Addendum

Global technical regulation No. 2

Corrigendum 1

MEASUREMENT PROCEDURE FOR TWO-WHEELED MOTORCYCLES EQUIPPED
WITH A POSITIVE OR COMPRESSION IGNITION ENGINE WITH REGARD TO THE
EMISSION OF GASEOUS POLLUTANTS, CO₂ EMISSIONS AND FUEL CONSUMPTION

Figure A13-1: Example of a gearshift sketch

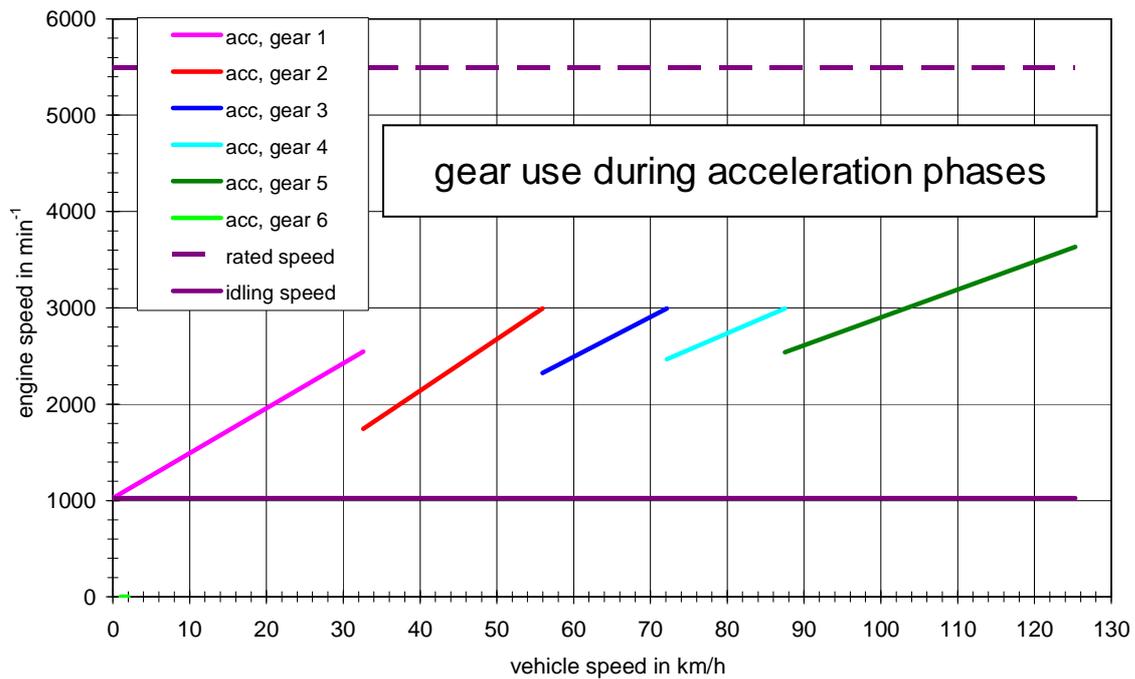
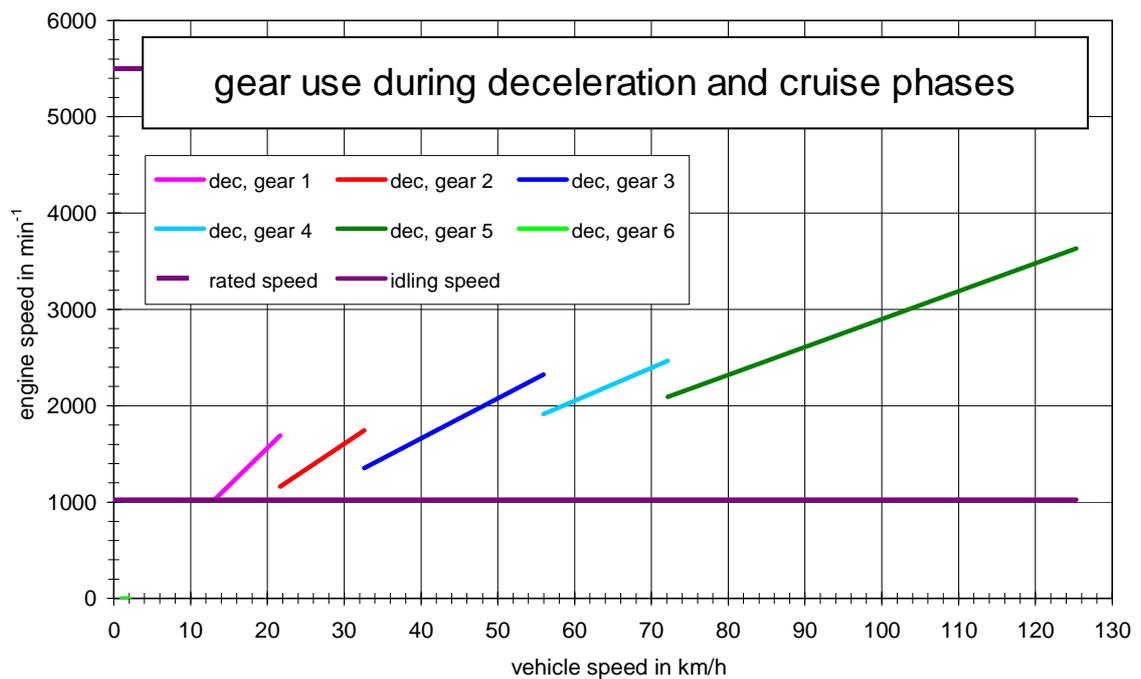
Annex 13, amend to read:

Figure A13-1 shows an example of gearshift use for a small vehicle.

- (a) The lines in bold show the gear use for acceleration phases.
- (b) The dotted lines show the downshift points for deceleration phases.
- (c) The cruising phases the whole speed range between downshift speed and upshift speed may be used.

Figure A13-2: Example for modified phase indicators

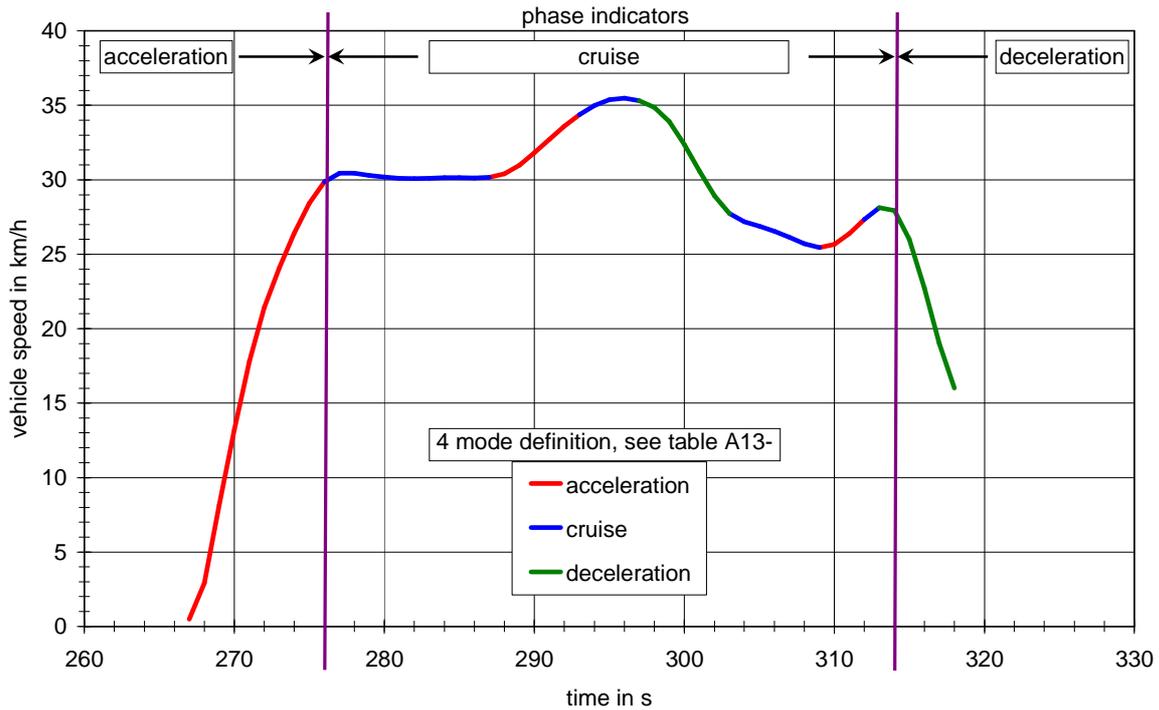
The indicators were then modified in order to avoid frequent changes during relatively homogeneous cycle parts and thus improve the driveability. Figure A13-2 shows an example from cycle part 1.
